## Hickory Woods Elementary SP 09-27

Public Hearing of the request of TMP Architecture, Inc., for Wetland Permit approval. The subject property is located in Section 2, north of Thirteen Mile, west of Novi Road, in the R-4, One-Family Residential District. The subject property is approximately 28.6 acres and the applicant is proposing the addition of four classrooms on the northeastern side of the school.

## PLAN REVIEW CENTER REPORT

Re: Hickory Woods Elementary School (SP09-27) Preliminary Site Plan Review for Wetlands

**REDUCED SITE PLAN**

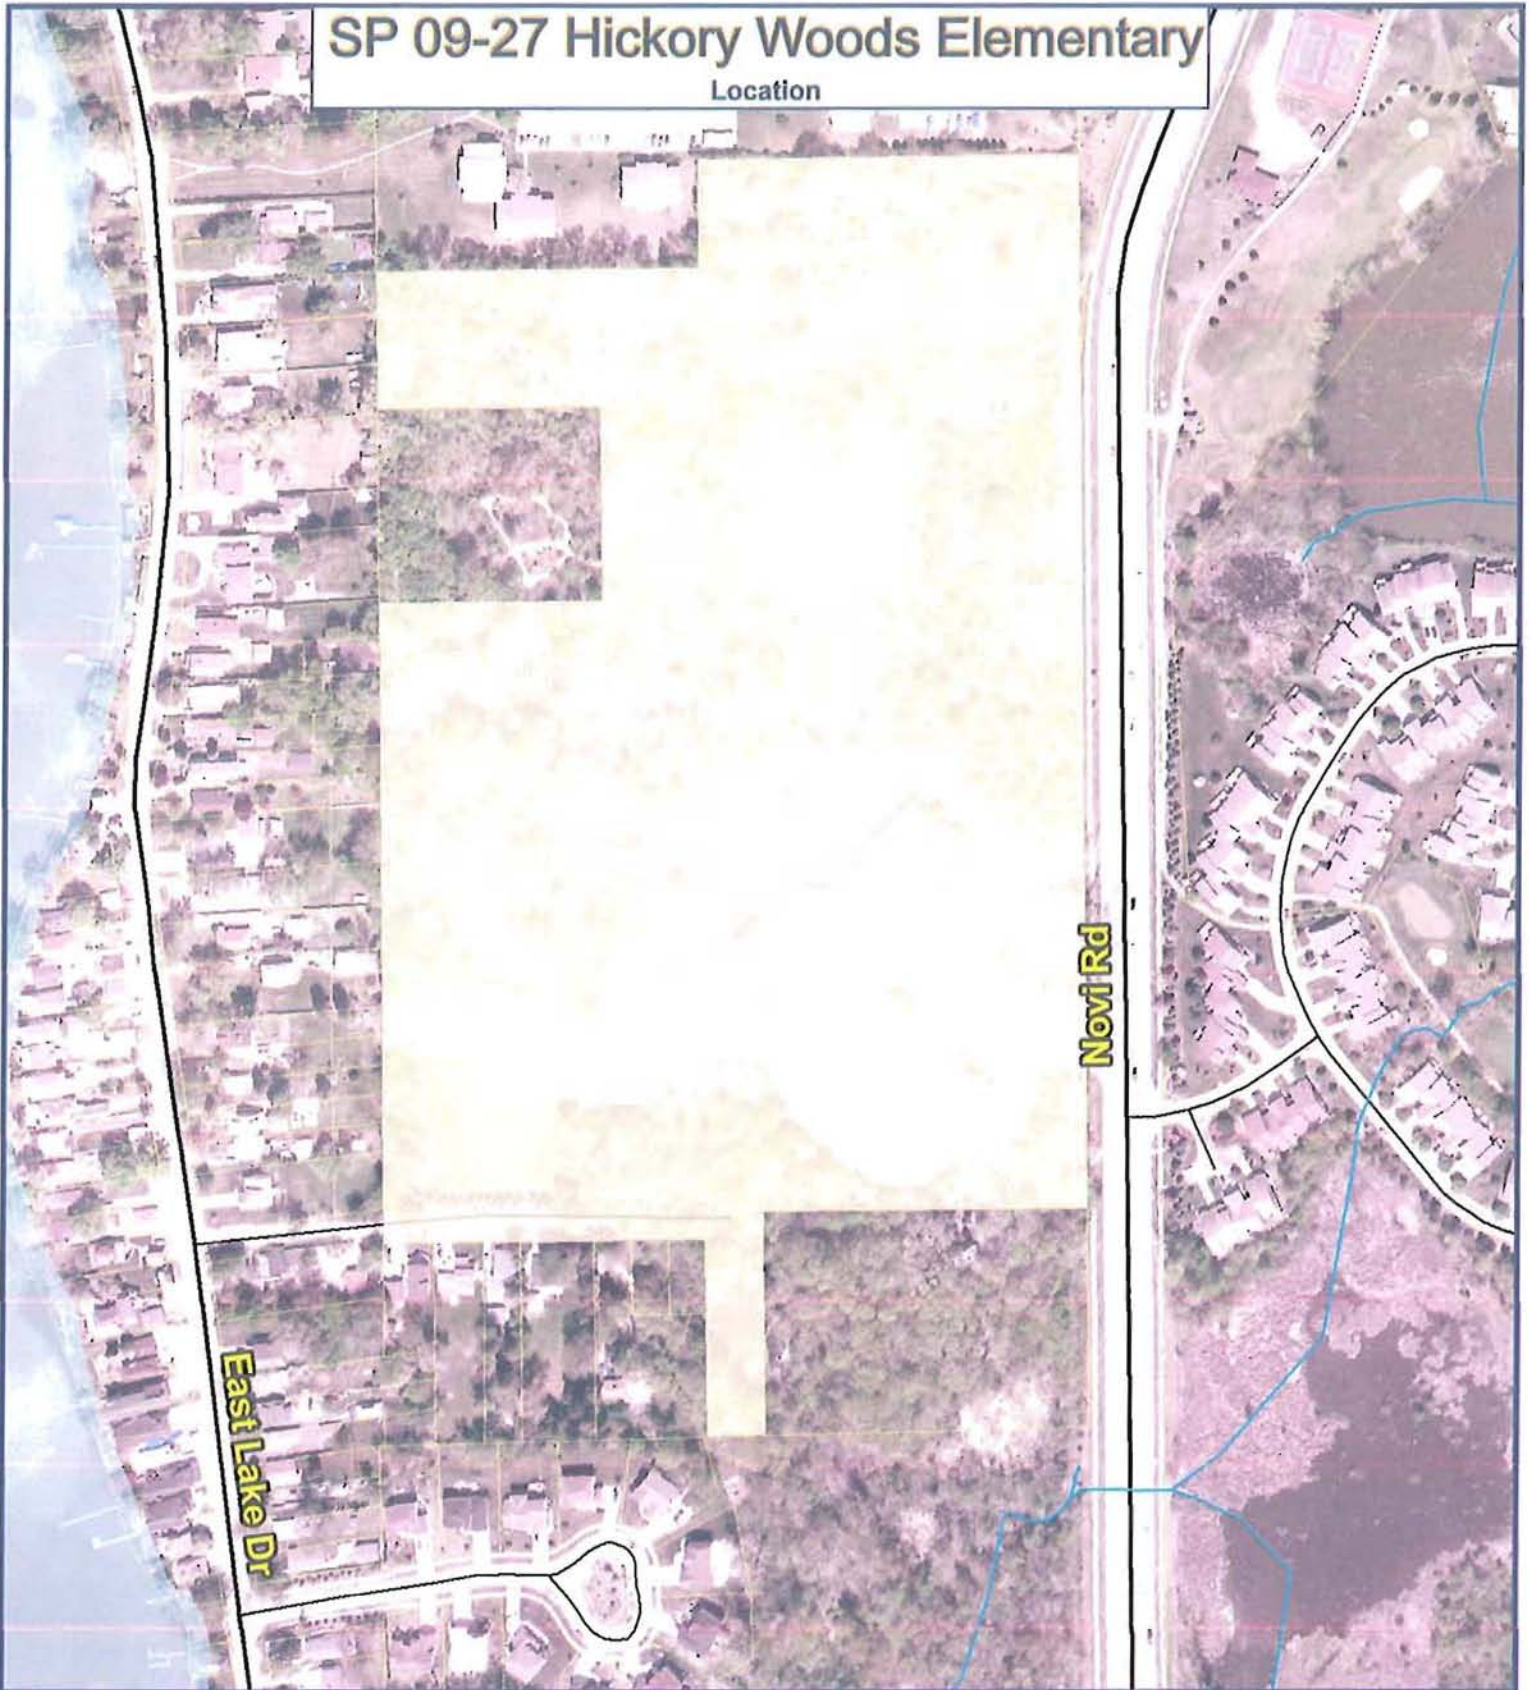
*Proposed wetland impact is placement of 469 cubic yards of fill into 4,371 square feet (0.1-acre).  
Proposed impact to the 25-foot Natural Features Setback is 5,945 square feet, or 0.136-acre.*

6. Lower the proposed lead invert in EX. MH#6 on the plan to within a foot of the lowest invert.
7. The minimum diameter of all roof leads is 8-inches. The proposed leads are 6-inch.

13. At least two of the nine parking stalls to be relocated do not meet the minimum 9-foot width as required per Section 2506 of the Zoning Ordinance. Any new stalls should meet the dimensional standards of the City's Zoning Ordinance.

6. We have lowered the proposed sewer lead invert at MH #6 as requested.
7. Private roof leads are not subject to local jurisdiction and have been left at 6" diameter. This size is adequate to handle the small amount of roof drainage.

11. Approach pavement cross section has been modified as requested.
12. Curb detail has been modified as requested.
13. Adhesive detectable warning strip has been indicated at the south side of the approach.
